Item Name: Dual High Back Seat Installation

DART SERVICE INSTRUCTION

TO AMEND INSTALLATION INSTRUCTIONS IIN-D350-689 REV. B AND INSTRUCTIONS FOR CONTINUED AIRWORTHINESS ICA-D350-689 REV. 1

REF. TCCA STC: SH02-33
REF. FAA STC: SR01620NY
REF. EASA STC: EASA.IM.R.S.01453
REF. TCA STC: 2005S03-09

FIGURE 1: UPDATES TO CROSS SECTIONS F-F AND M-M

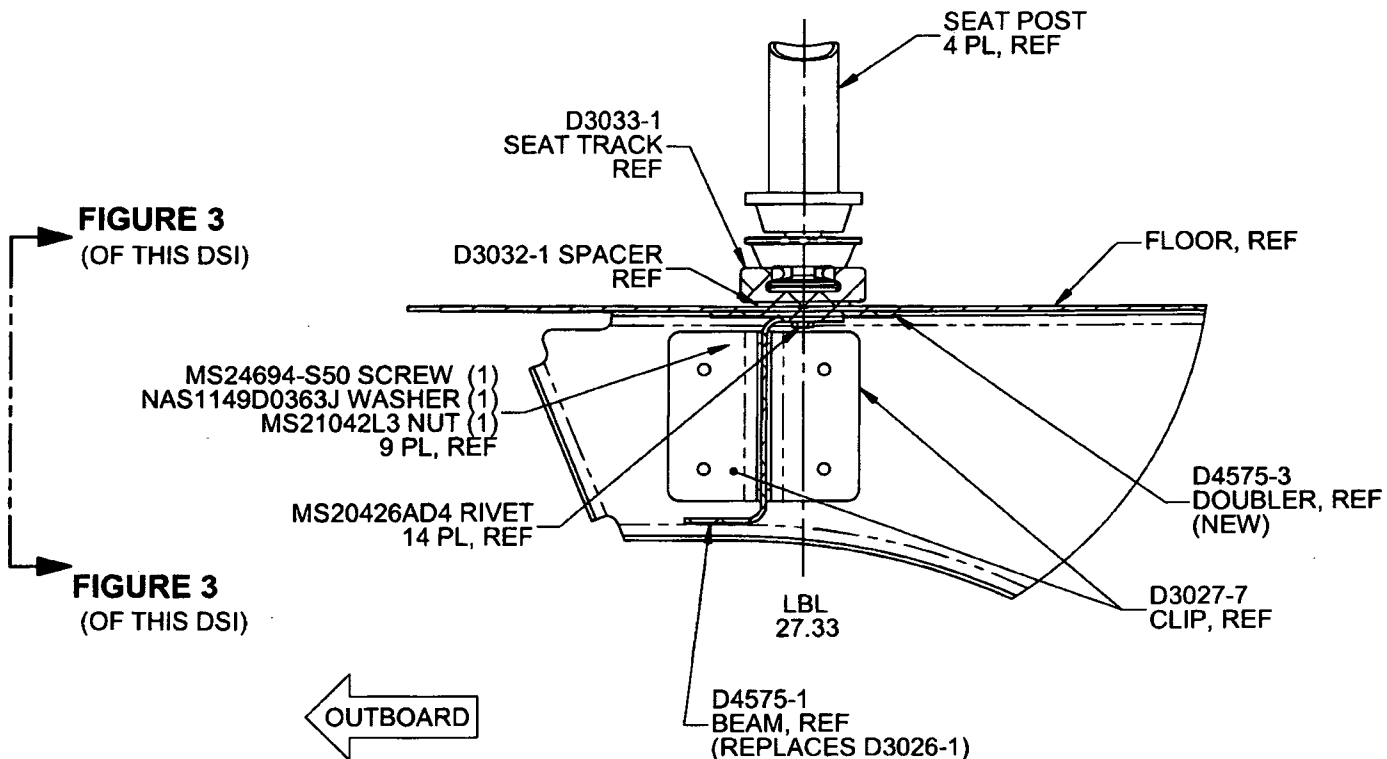
If there is an existing stringer at LBL 27.33, it will need to be removed from that location. Locate D4575-1 Beam, D4575-3 Doubler, and D3032-1 Spacer as shown in Figure 1 of this Service Instruction. Transfer drill existing holes from the aircraft floor to the D4575-1 Beam, D4575-3 Doubler, and D3032-1 Spacer. Ensure 1.0" to 1.5" rivet pitch and add additional holes if required. If there is no existing stringer, locate D4575-1 Beam, D4575-3 Doubler, and D3032-1 Spacer as shown in Figure 1 of this Service Instruction and drill Ø0.128" holes on a 1.0" to 1.5" pitch.

If there is an existing stringer at LBL 27.33, it will need to be removed from that location. Locate D4575-1 Beam and D4575-3 Doubler as shown in Figure 2 of this Service Instruction. Transfer drill existing holes from the aircraft floor to the D4575-1 Beam and D4575-3 Doubler. Ensure 1.0" to 1.5" rivet pitch and add additional holes if required. If there is no existing stringer, locate D4575-1 Beam and D4575-3 Doubler as shown in Figure 1 of this Service Instruction and drill Ø0.128" holes on a 1.0" to 1.5" pitch.

FIGURE 3: RELIEFS ON D4575-1/-3
(ONLY D4575-1/-3 SHOWN FOR CLARITY)
VIEW LOOKING INBOARD

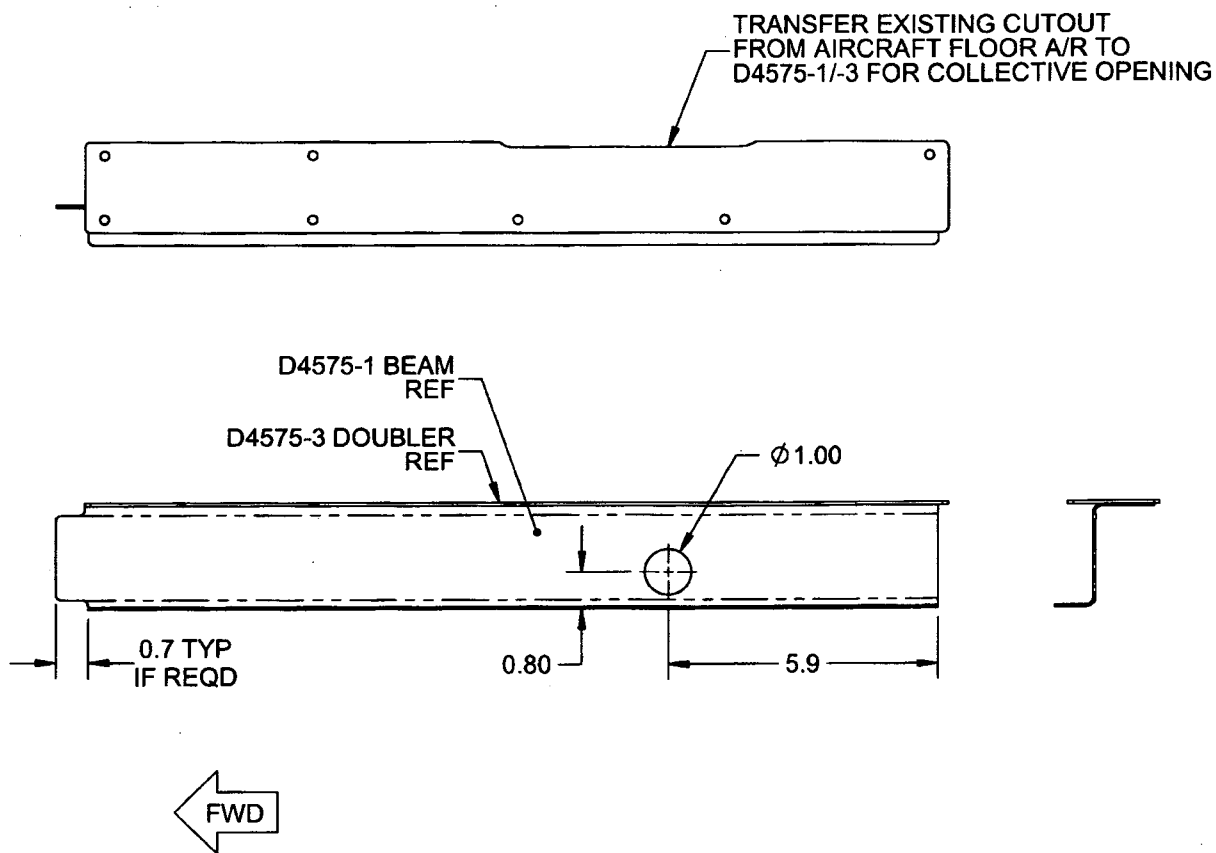
Note: Drill a Ø1.00" (Ø25.4 mm) hole in the D4575-1 Beam to clear extension tube of collective and cutout as required for clearance of collective opening and fwd bulkhead as shown in Figure 3 of this Service Instruction.

Note: Drill a Ø1.00" (Ø25.4 mm) hole in the D4575-1 Beam to clear extension tube of collective and cutout as required for clearance of collective opening and fwd bulkhead as shown in Figure 3 of this Service Instruction.
